From: Schultz, Josie M - DNR
Sent: Monday, January 22, 2024 12:03 PM
To: Nicholas Hill
Cc: Wayne Fassbender
Subject: RE: Barb & Rons 02-45-297744

From: Schultz, Josie M - DNR <josie.schultz@wisconsin.gov>
Sent: Wednesday, November 15, 2023 1:10 PM
To: Nicholas Hill <nhill@enviroforensics.com>; Wayne Fassbender <wfassbender@enviroforensics.com>
Cc: Andy Skwierawski <mas@hallingcayo.com>
Subject: Barb & Rons 02-45-297744

VAPOR INTRUSION CONDITIONS AND PROPOSED SAMPLING LOCATIONS

Former Barb and Ron's Cleaners
1700 South Lawe Street
Appleton, Wisconsin

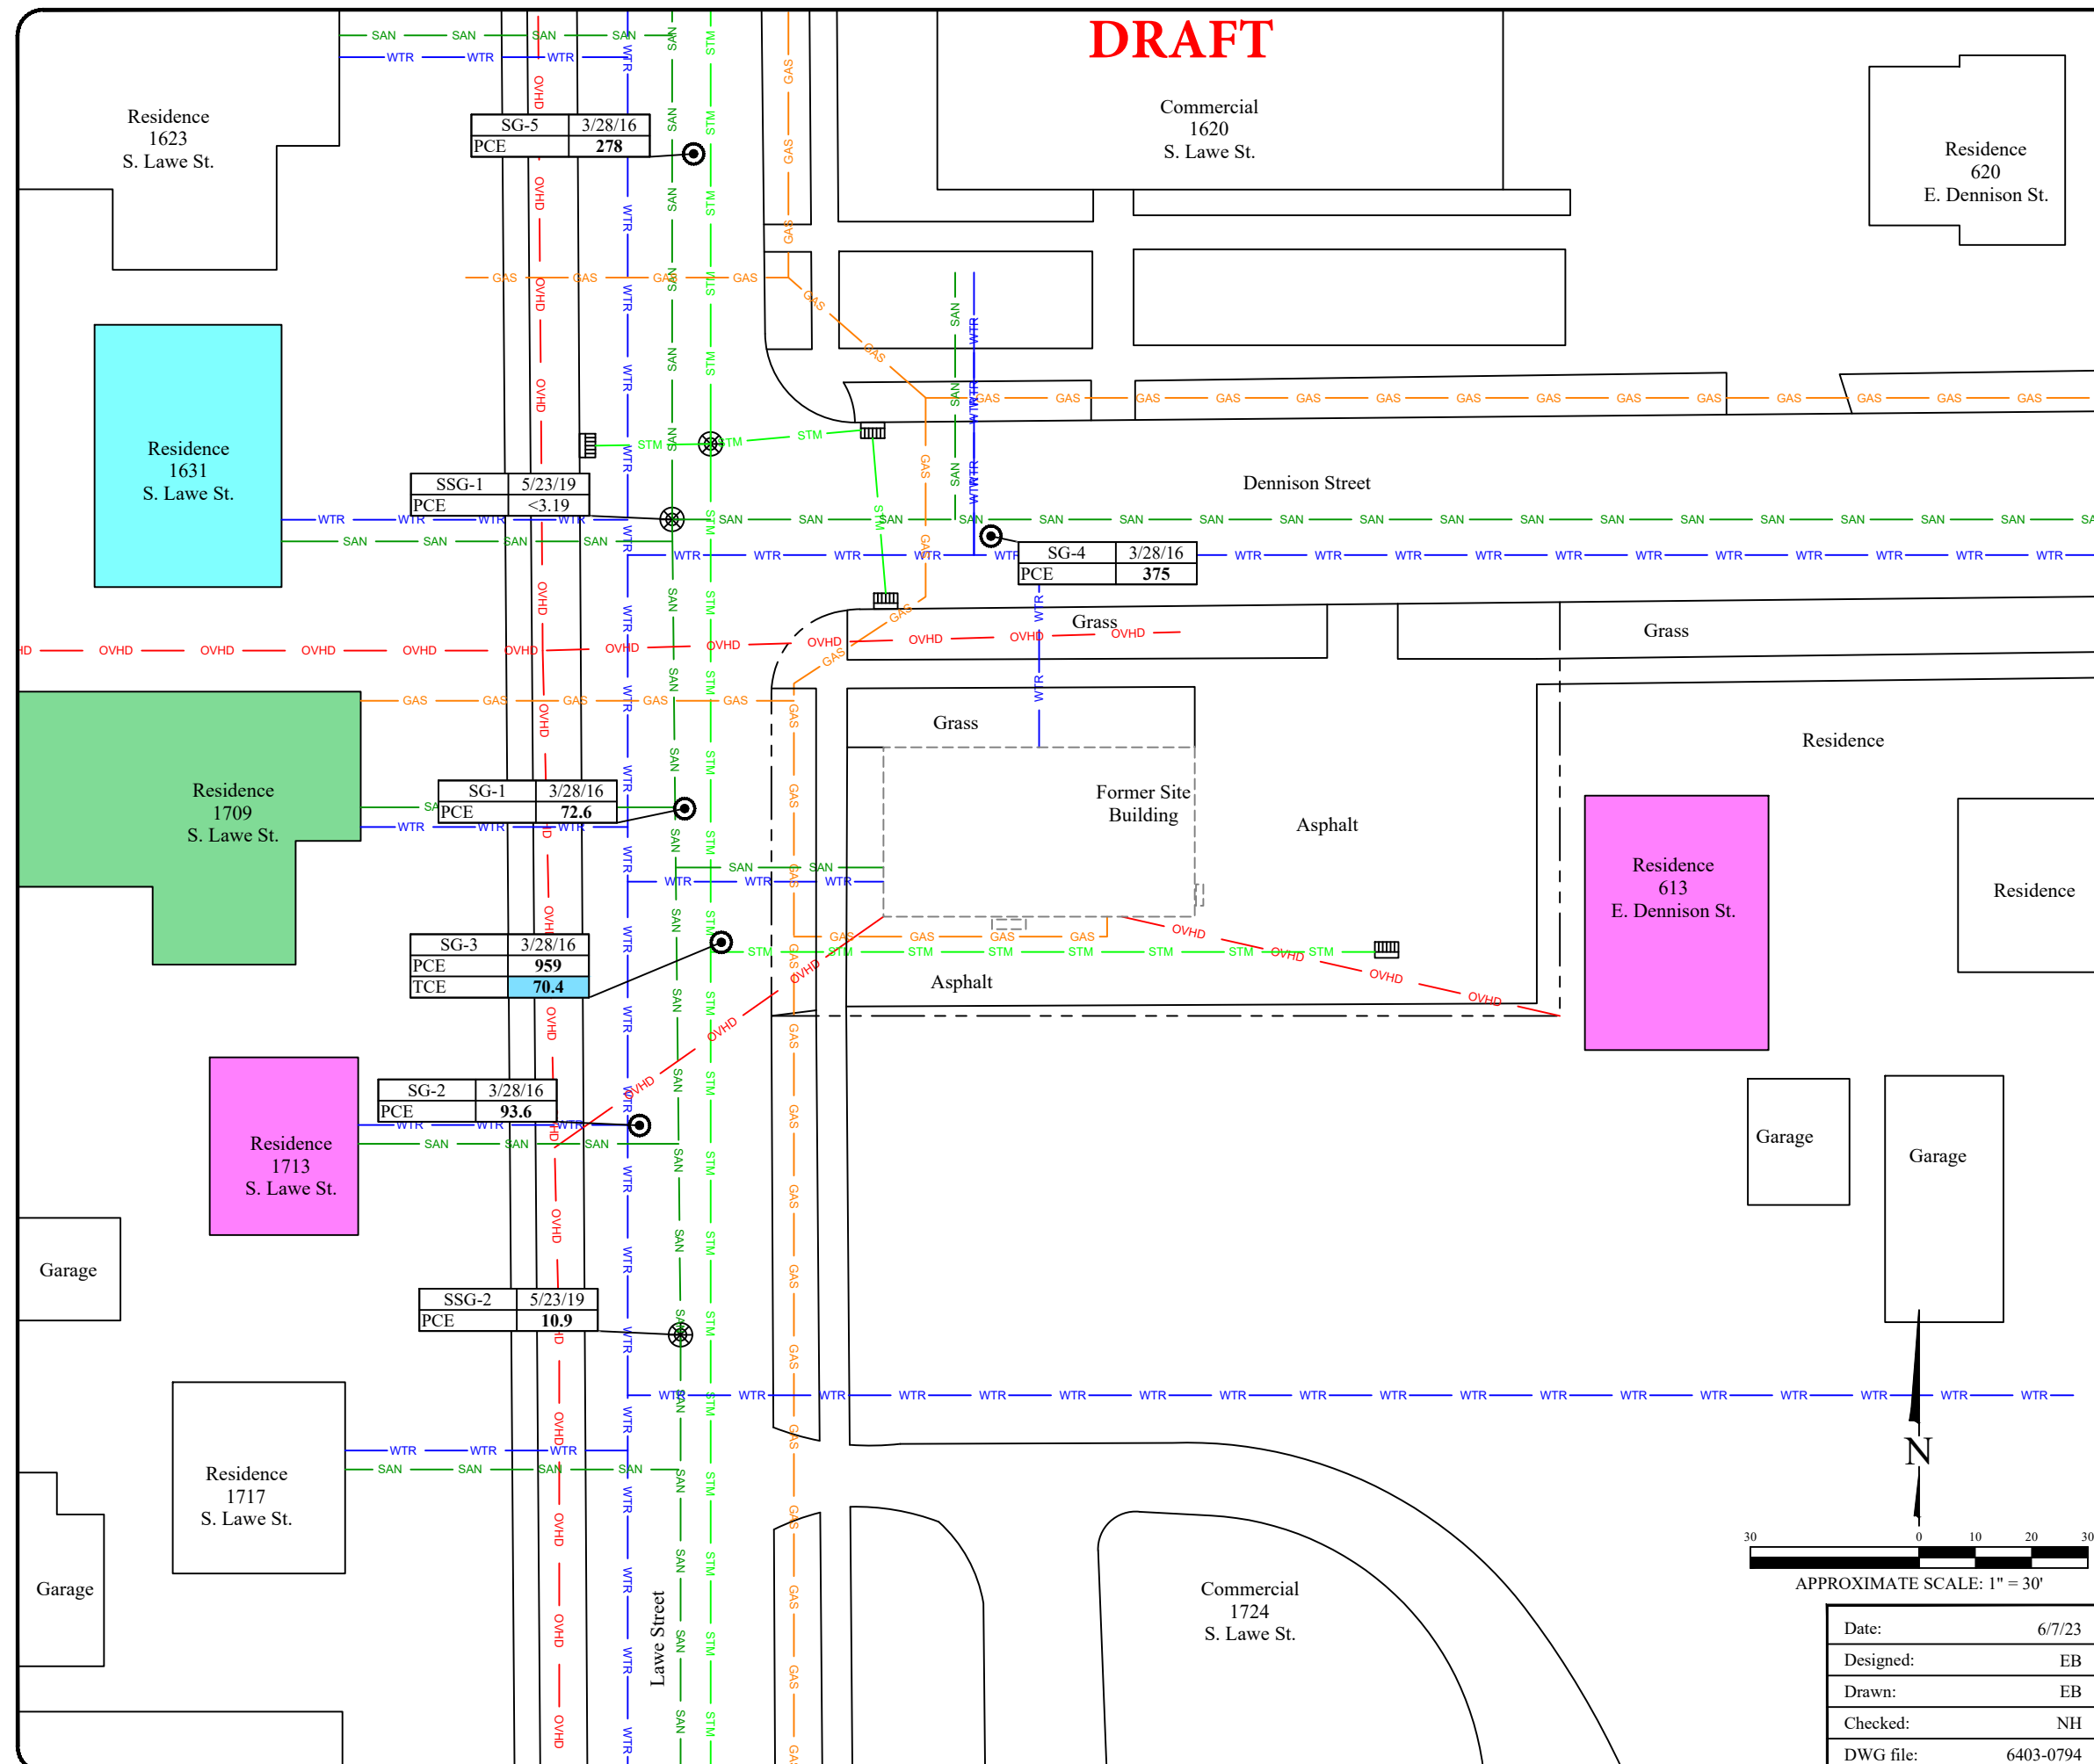
In follow up with your email below, we are working toward addressing your comments. As a start, we gathered some additional information regarding the sewer system north of the Site to address your comment #3 and would like to discuss further with you before updating the FSI work plan. Attached is an email chain with the City of Appleton civil engineer discussing the sewer network in the area and a map showing our understanding of the conditions. In summary, it appears that a 6-inch clay tile lateral may have historically extended north from the site to the 8-inch concrete main in Dennison, but was removed (capped) along with the newer sewer (6-inch PVC) and water (1.5-inch copper) laterals extending west toward Lawe Street between 2016 and 2018. In our opinion, the capping of the laterals from the site should mitigate the potential for the sewers to act as a continued preferential pathway for impacted vapor migration. Additionally, given the completed source reduction actions at the site, vapor

impacts at SG-4 are below residential screening levels, and we are planning to conduct VI assessments at the 3 residences along Lawe Street and the one (1) western adjoining residence on Dennison (see map), further vapor investigation of the sewer along Dennison does not seem warranted.

I passed this information along to the vapor intrusion team leader, and she agreed that no additional investigation is warranted in the Dennison sanitary sewer main or backfill.

PMT030R7 SEWER PERMIT INQUIRY S16 - 0226 PMT030D1
 KEY # 4 0761 01 RCPT# 8355 AMT 30.00 DATE 042716 ALD DST 08
 OWNR GLASS VAULT LLC PO BOX 2327 CLASS COM
 BLD ADDR 1700 S LAWE ST ZONES: C2
 LGL DESC: EDW WESTS PLAT 4WD N5 6FT OF S112FT OF W120F T OF LOT 1 BLK 37

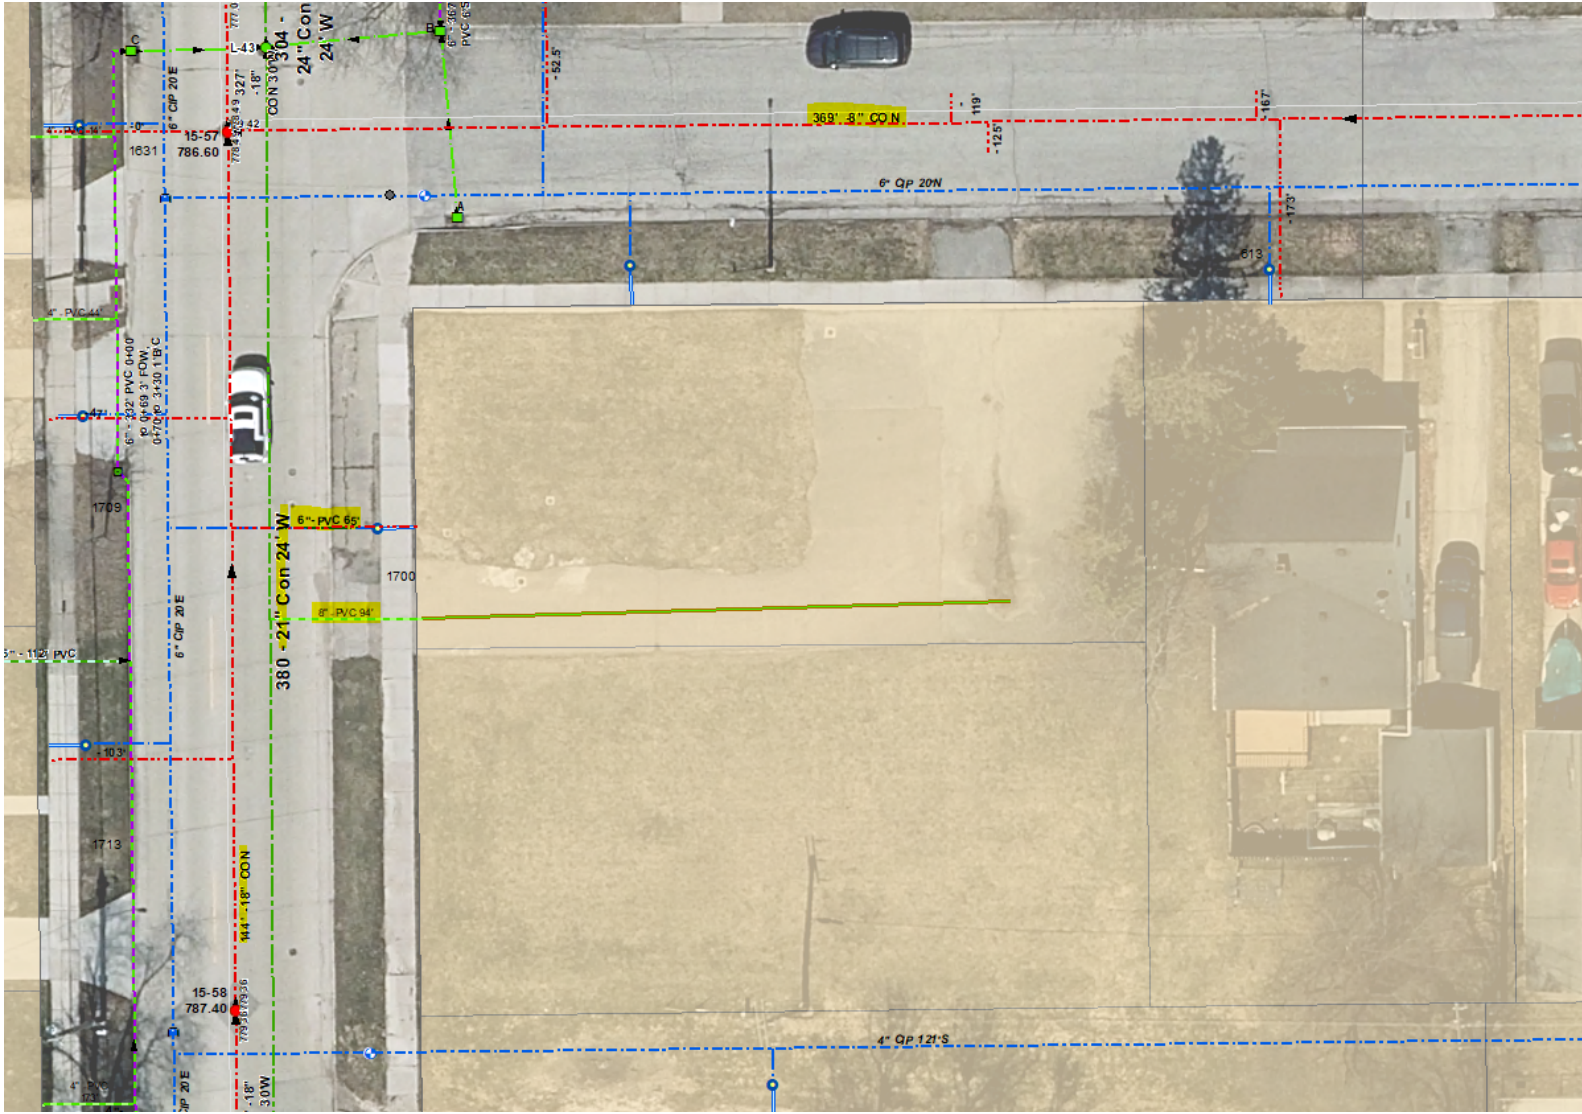
- There was a lateral that went from Barb and Rons to the Dennison sanitary sewer. The lateral was capped at some point between 2016 and 2018, I'm guessing as part of the RA.
- Sanitary flows to the west. There is a SSG sample from the nearest manhole in the downgradient direction, at the intersection of Lawe and Dennison that was non-detect.

VAPOR INTRUSION CONDITIONS AND PROPOSED SAMPLING LOCATIONS

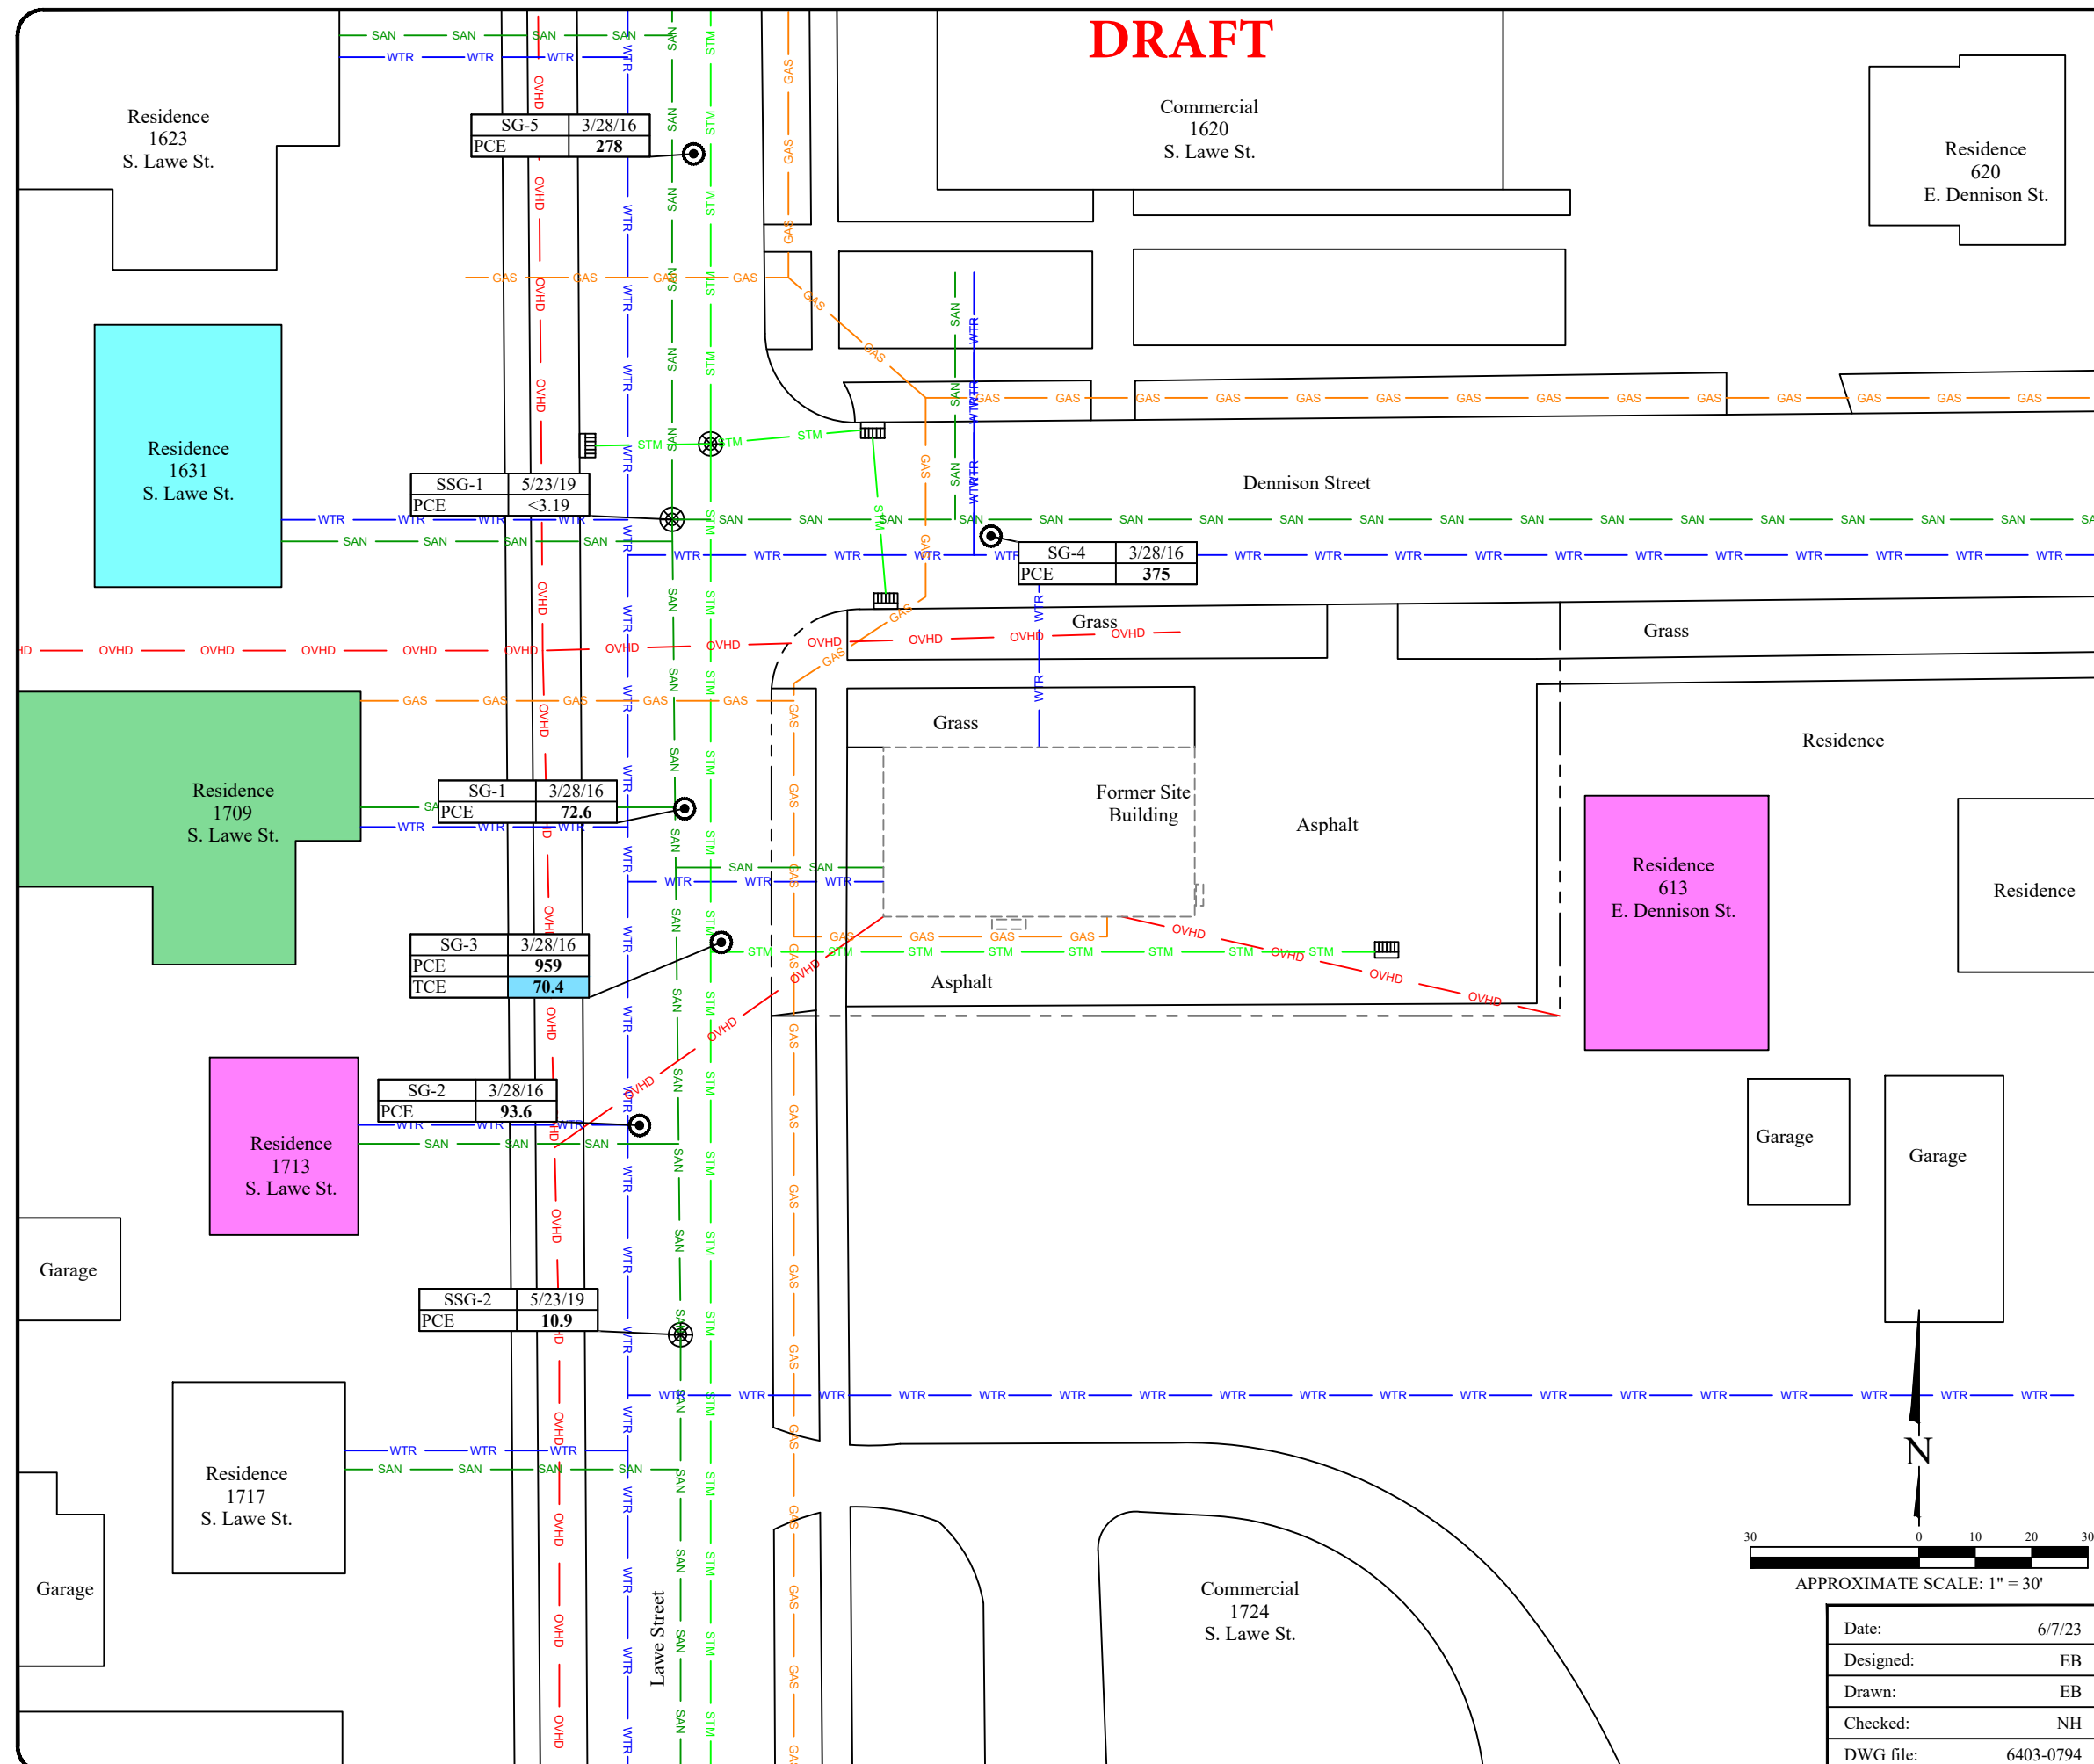
I received the attached email for Barb & Rons, addressing whether or not there was a historic lateral that went into East Dennison to the north of the site. When you were the PM for the site, you requested this additional information to help explain soil gas detections at SG-4 near the sanitary in Dennison Street (see map below)

- **Is additional investigation needed into this sanitary sewer?**
 - My opinion:
 - No additional investigation needed in-pipe as the closest downgradient manhole is clean.
 - No additional backfill soil gas investigation needed as the soil gas vapor is below residential VRSLs, saturated soil in this location was non-detect, and additional vapor investigation will be performed in all the homes.

Josie – I reviewed this information this morning and agree with you that no additional investigation is warranted in the Dennison sanitary sewer main or in the backfill. Let me know if you need anything further.
